Access Compliance Report

Public Rights-of-Way

(Curb Ramps)

Intersection ID: 44077	Main Street: NEWLANDS_CORNER_LN	Cross Street: FOREST_RUN_LN	Location: NW
ADA ID: C0CD2EC207E0	Ramp Type: BlendTrans1	Initial Pass/Fail: Fail	Overall Compliance: No
Severity Score: 36.25			
Codes/Mitigation Info/Possible Solution		Field Measurements/Component Compliance

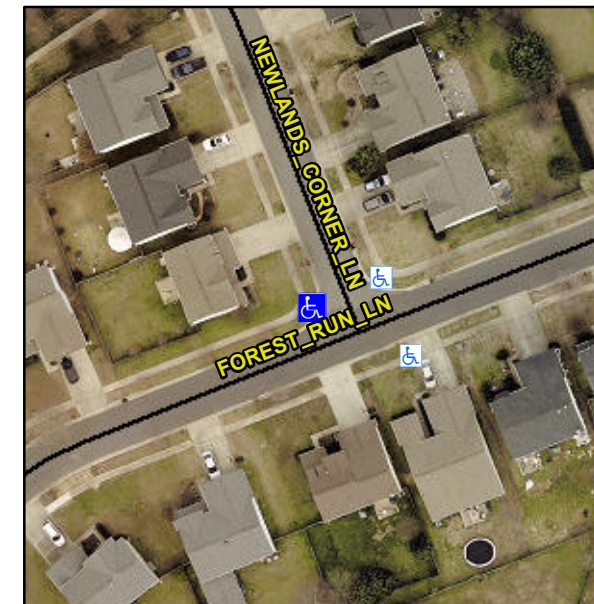
GTR GAP 1.5

R304.5.1, R304.5.3

Compliance	Description	Data	Compliance	Description	Data
N/A	Ramp Length (in)	70.0	Yes	BlendTrans Slope (%)	2.5
No	Ramp Width (in)	25.0	No	BlendTrans XSlope (%)	3.6
N/A	Flare Type LT	N/A	N/A	Flare Type RT	N/A
N/A	Flare Slope LT (%)	N/A	N/A	Flare Slope RT (%)	N/A
N/A	Flare Traversable LT?	N/A	N/A	Flare Traversable RT?	N/A
N/A	Landing Length (in)	N/A	N/A	DWS Provided?	N/A
N/A	Landing Width (in)	N/A	N/A	DWS Contrast?	N/A
N/A	Landing Slope (%)	N/A	N/A	DWS Length (in)	N/A
N/A	Landing X Slope (%)	N/A	N/A	DWS Full Width?	N/A
N/A	Landing Curb? (Y/N)	N/A	N/A	DWS Offset (in)	N/A
N/A	Shared Landing?	N/A			
N/A	Gutter Ponding?	N/A	N/A	Gutter Slope (%)	N/A
N/A	Gutter Lip Ht (in)	N/A	N/A	Gutter X Slope (%)	N/A
N/A	Painted X Walk1?	No	N/A	Painted X Walk2?	No
	X Walk 1 Direction	To SE		X Walk 2 Direction	To NE
	X Walk 1 Width (in)	N/A		X Walk 2 Width (in)	N/A
	X Walk 1 Slope (%)	2.8		X Walk 2 Slope (%)	3.2
	X Walk 1 X Slope (%)	2.8		X Walk 2 X Slope (%)	0.5

Remove & Replace Curb Ramp With Two New Directional Ramps or Equivalent.
